# Access Compliance Report Public Rights-of-Way (Curb Ramps)

| Main Street: SIENNA_PKWY                |                                   | Cross Street: O_NEILL_DR |                                         | Location:       | SW |
| ADA ID: RPRK211111125137                | Ramp Type: Type 1 - Perpendicular | Initial Pass/Fail: Fail  | Overall Compliance: No                  | Severity Score: | 16 |

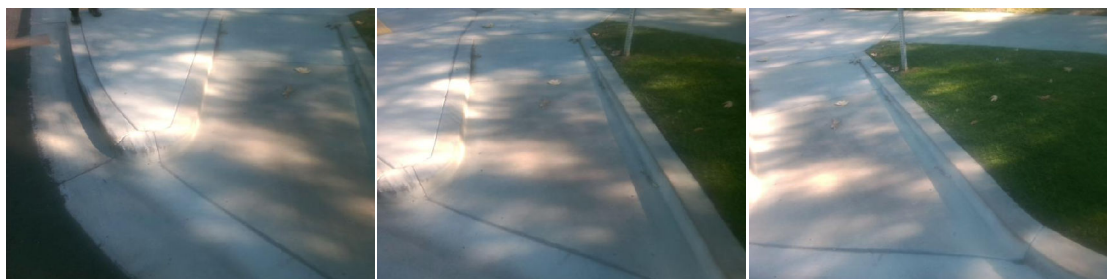
| Compliance | Description                           | Data | Compliance | Description                   | Data |
|------------|---------------------------------------|------|------------|-------------------------------|------|
| No         | Ramp Run Slope (%)                    | 9.4  | N/A        | Flare Slope LT (%)            | N/A  |
| N/A        | Gutter Ponding                        | N/A  | No         | Curb Slope                    | 10.1 |

Remove & Replace Entire Ramp.
